Project: Tweed Valley Hospital Multideck Carpark
Location: 771 Cudgen Road, Cudgen, NSW
Subject: Green Wall Omission

RE: Response to Department of Planning, Industry and Environment (DPIE) for the Tweed Valley Hospital Stage 2, Modification 3 - Tweed Shire Council Comments of Green Wall to External Facade.

REFERENCE NUMBER
ADCO Con-RFI-000234

Figure 20: Ground Floor Plan

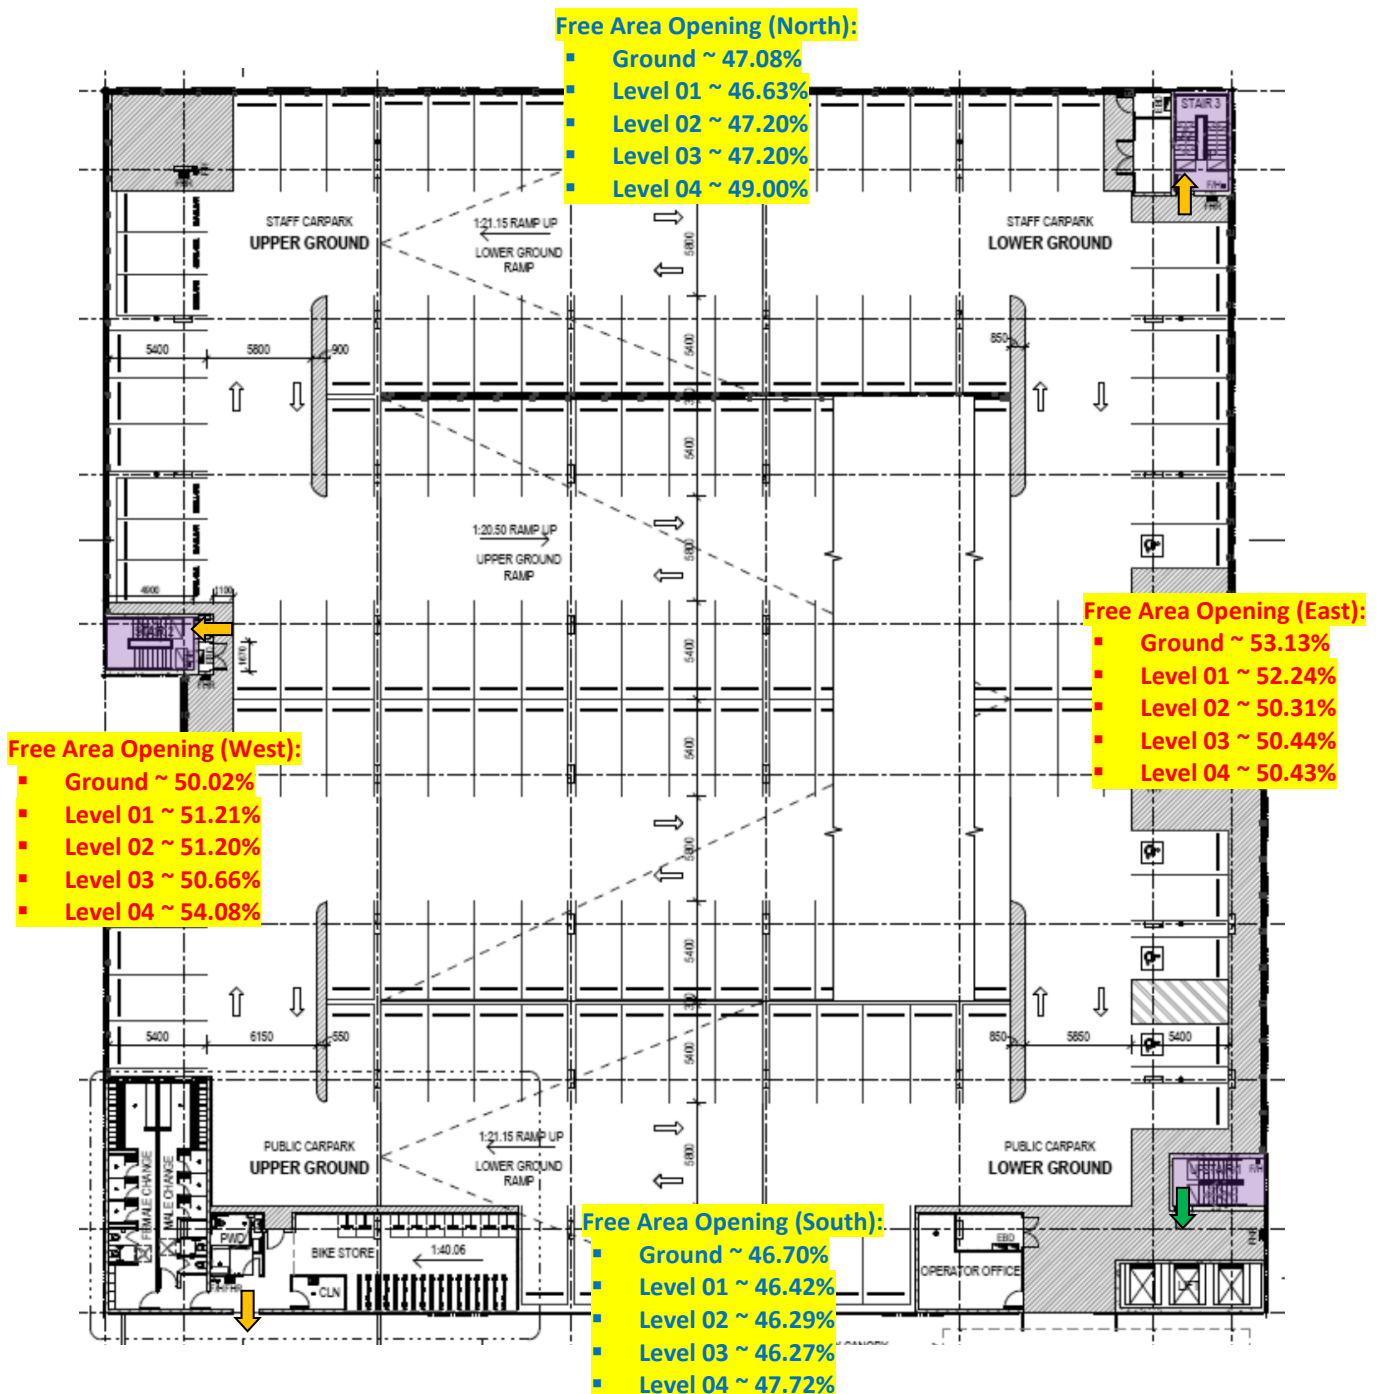
- FRNSW also notes that the performance solution is heavily-reliant on the natural ventilation provided by the open-deck nature of the above-ground levels of the carpark. Given that this natural ventilation is to be relied upon, the assessment is to quantitatively demonstrate that this will provide/maintain tenable conditions such that safe occupant egress provisions are provided at all times given a worst-case credible fire scenario. Consideration should be given to the impact of local wind conditions on the proposed natural ventilation design. Is there a potential for local wind climate to impact on smoke spread within the carpark levels? This is to be addressed.

Innova: The revised percentage of free area openings within the façade of the open deck levels of the car park have been summarised in the table below.

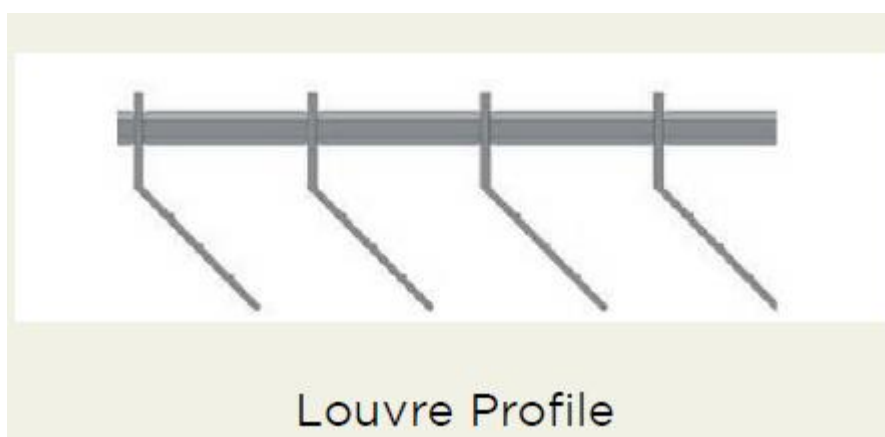
The following additional information is required in regards to required ventilation for open-deck carpark:

- + Updated plans required depicting compliance. The final openness to be reflected in FEBQ submission. Final façade plans to be consistent to Mod SSD plans.
- + Façade plans are required to demonstrate available openness is provided for ALL upper levels. Level 5 shall be included in the façade schedule.
- + Additional construction tolerance / design redundancy for free ventilated area is required. Anything less than 60% or 55% for ground level south will not comply FRNSW / FER requirements. Ground North requires additional ventilation over the 60% for design redundancy.
- + Please evidence on the percentage of openness from supplier for proposed sun shading louvre screen (FS-263).

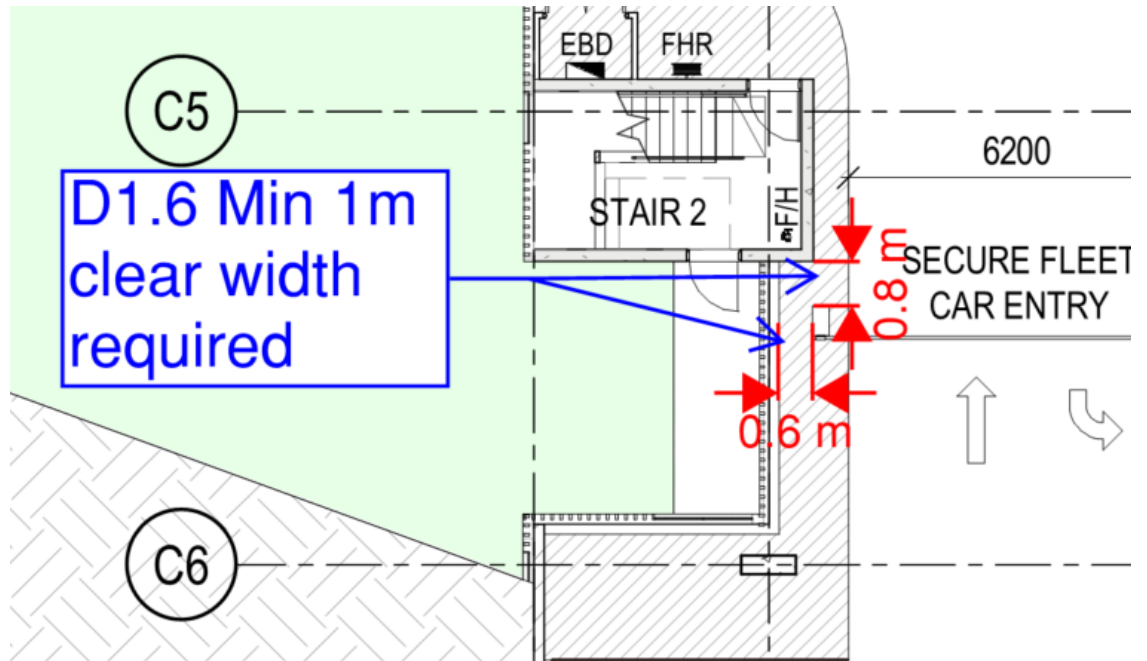
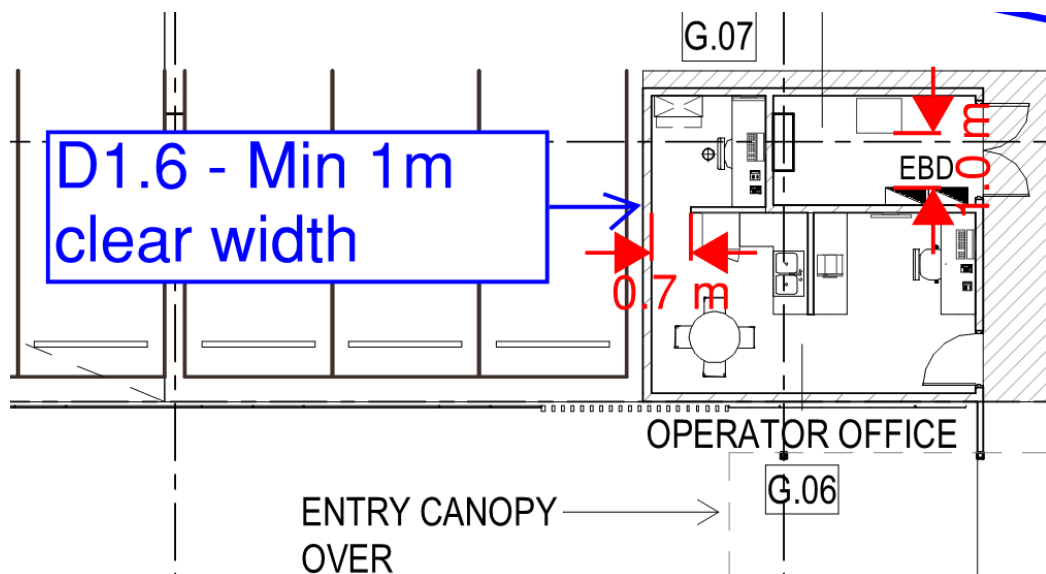
D1.6	<u>Dimensions of Paths of Travel to an Exit:</u> The minimum clear height through all egress paths is required to be no less than 2m, and a minimum of 1m wide (this width dimension is measured clear of any obstructions such as handrails and joinery). In a required exit or path of travel to an exit there is concession for the unobstructed width of a doorway to be reduced to 850mm min in lieu of 1m, and the unobstructed height for an exit doorway can be reduced to 1,980mm min. Further Information Required Egress paths require a clear unobstructed width not less than 1m. There are egress paths that are less than 1m and require rectification throughout. Ensure a minimum 1m clear unobstructed throughout all areas. B2 requires further design development to ensure a path is available around boom gate.

Similarly the operator office is to ensure the nib wall has a min 1m clear unobstructed width.

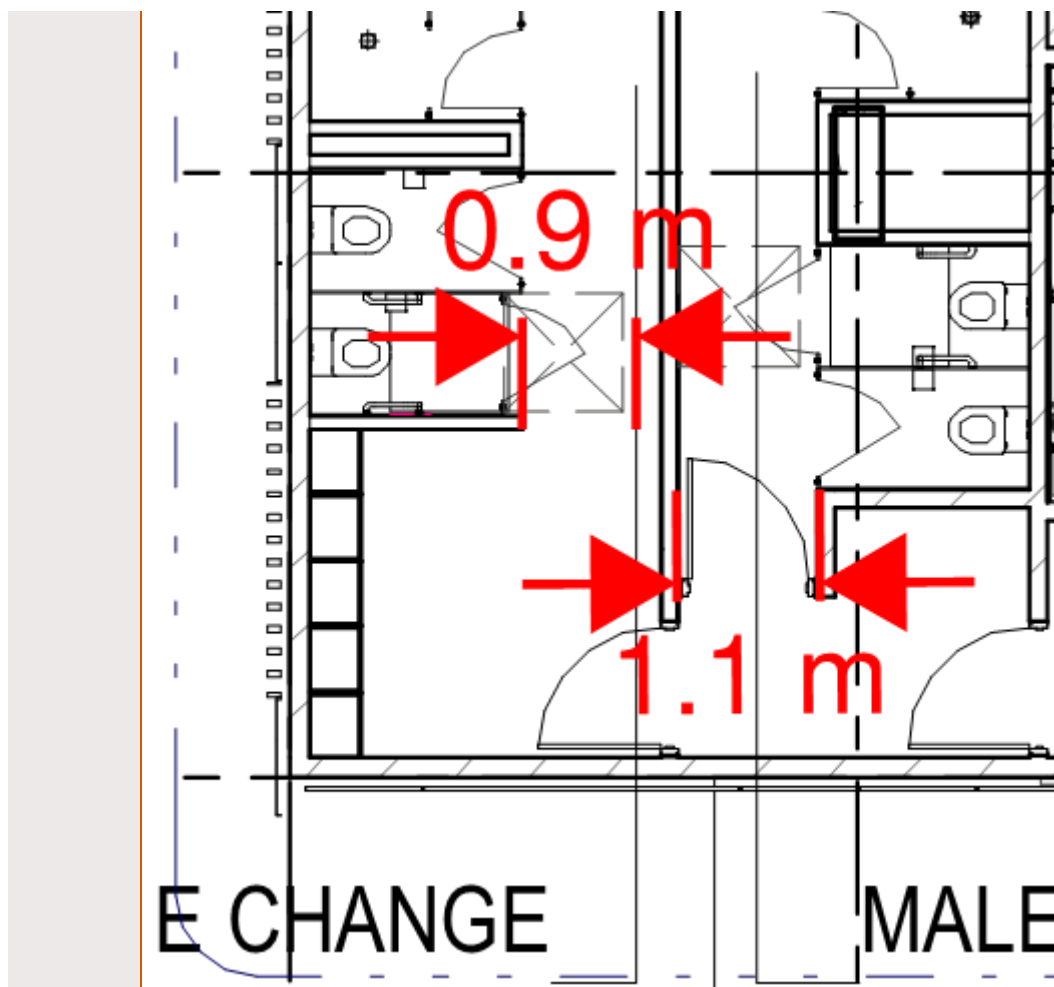
The end of trip facilities shall ensure a minimum clear 1m width.

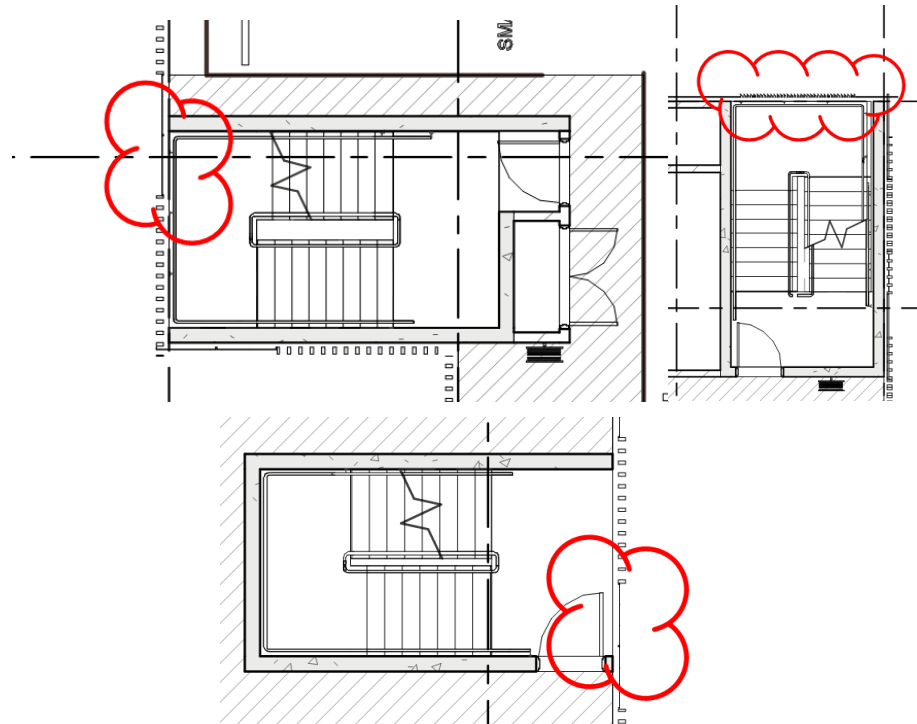
Updated façade plans do not depict >60% ventilated area on external stairs. Updated façade plans are required to confirmation is required that external stairs in lieu of fire isolated have >60% open for full length of façade that is not exposed to the building.

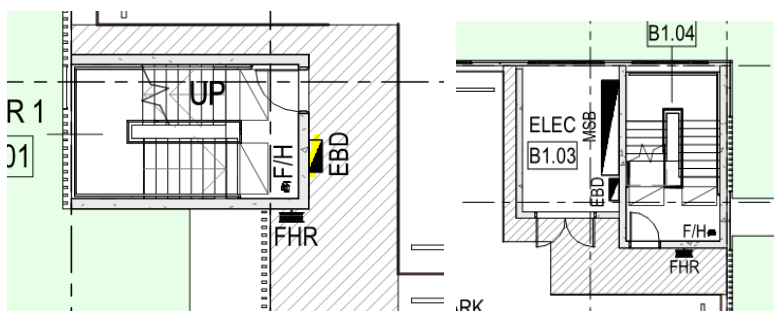
Confirmation is required that permissible gradients are located at discharge points.

Suitable barriers (bollards) are to be introduced to prevent vehicles from blocking access to the exit. A minimum 1m clear width shall be maintained.

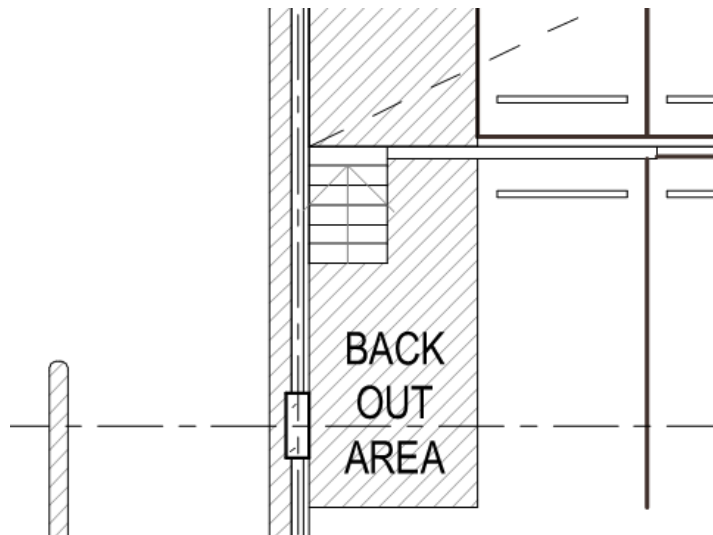
Confirm a balustrade is provided at the stair between lower B1 and upper B1 area.

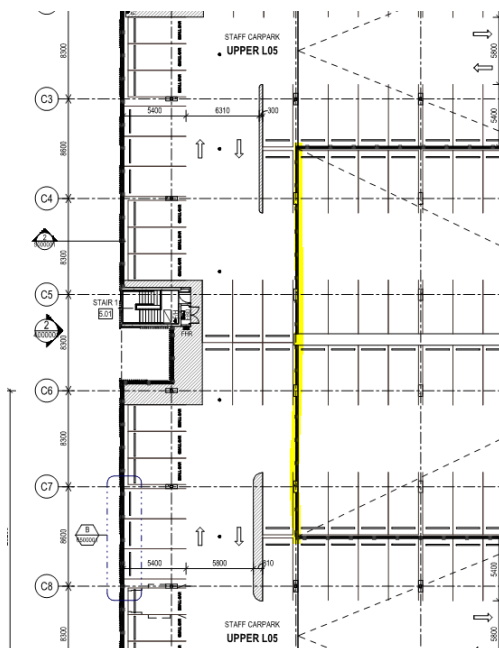
Balustrade between different carpark levels to confirm compliance.

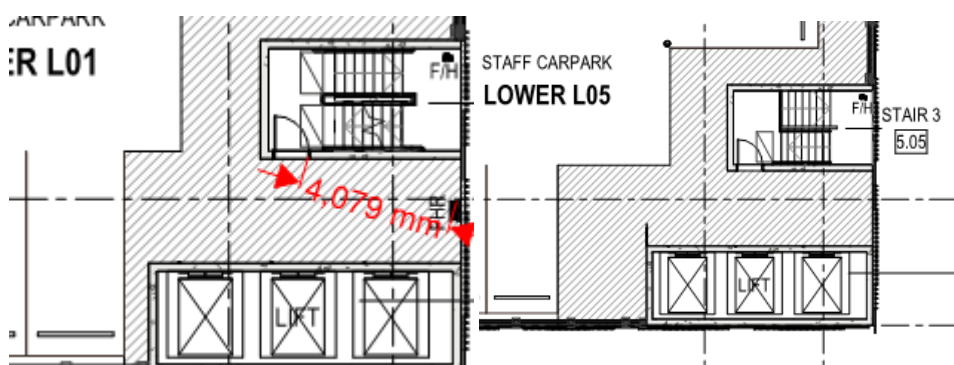
- + Ensure stair 3 FHR is <4m from exit, scaled plans appear just over. Level 5 requires a FHR within 4m of stair 3 exit prior to supplementary FHR being located throughout.

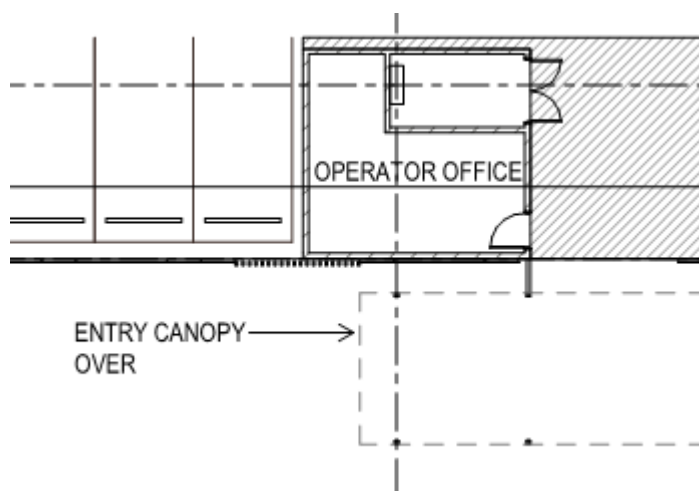
Please provide a performance solution for damp and weatherproofing, the solution shall confirm how compliance with the performance requirement FP1.4 will be achieved for operators' office and any retail spaces proposed. The solution shall also address how drainage at door is achieved.

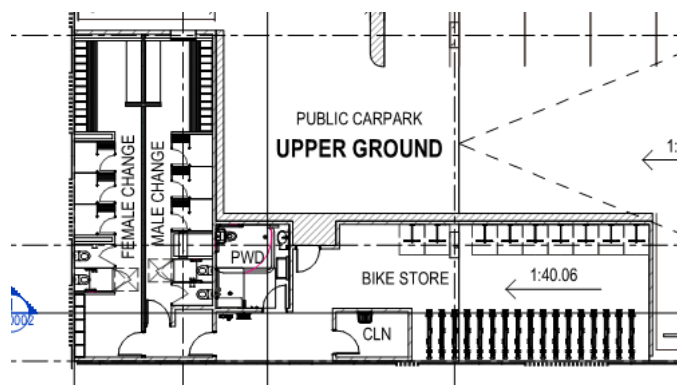
Please confirm if retail spaces are intended to be provided and number of persons proposed to be accommodated so provision of sanitary facilities can be confirmed.

Locations of basins are to be confirmed on plans.
